PACIFIC GAS AND ELECTRIC COMPANY

June 10, 1983

Re: Docket No. 50-275, OL-DPR-76
Docket No. 50-323
Diablo Canyon Units 1 and 2
Proposed FSAR Revision per 10 CFR 50.54

Enclosed is a proposed change to Chapter 17 of the Diablo Canyon Power Plant Final Safety Analysis Report for your review and approval per 10 CFR 50.54. The enclosure would replace Chapter 17 in its entirety.

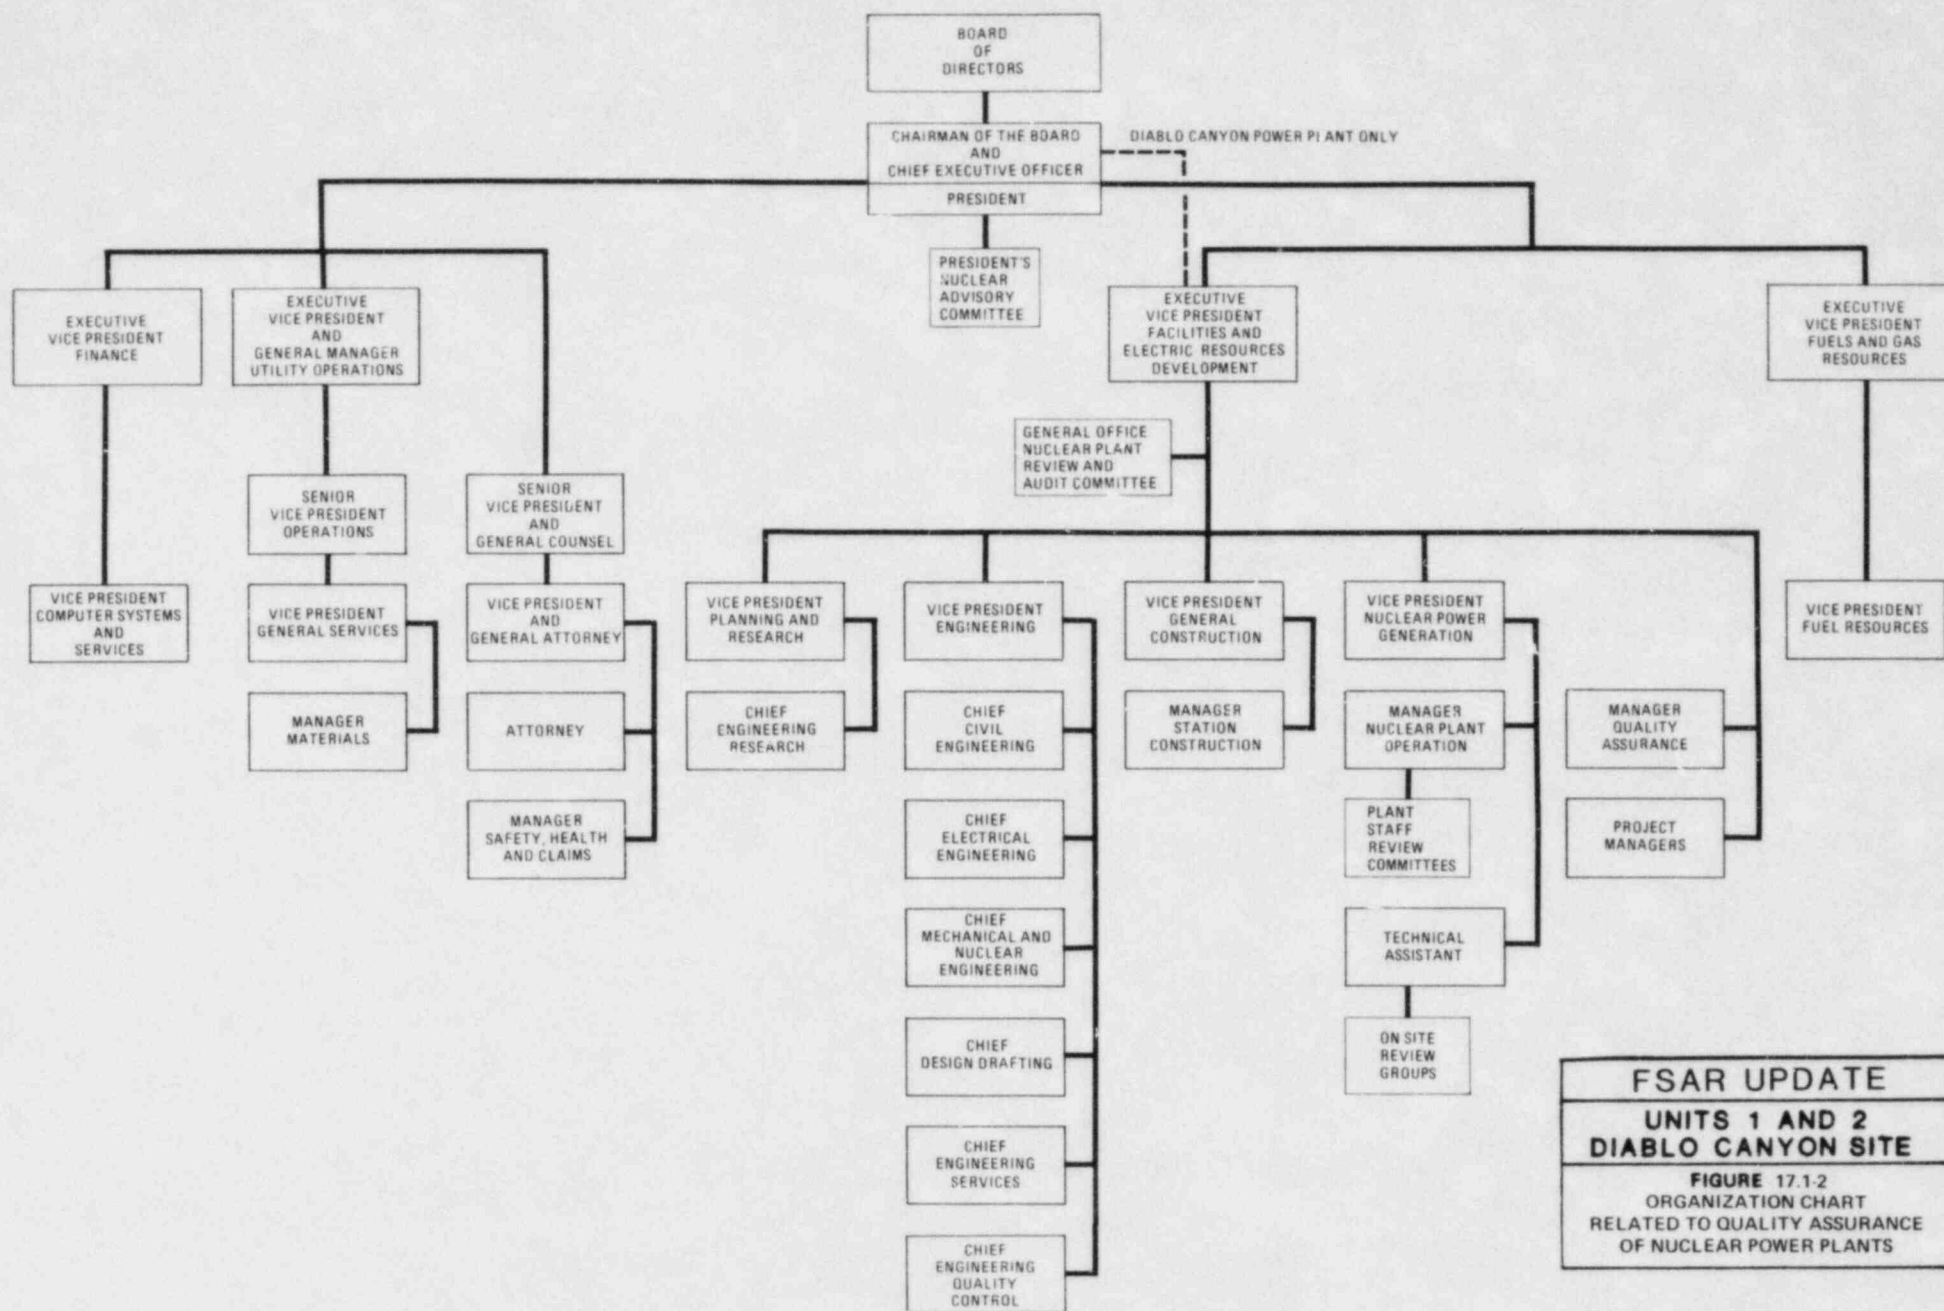
The present Chapter 17 description paraphrasing the Quality Assurance Manual has been replaced by directly referencing the Manual. The position of the Manager, Quality Assurance, has been revised to report to a higher level of executive management.
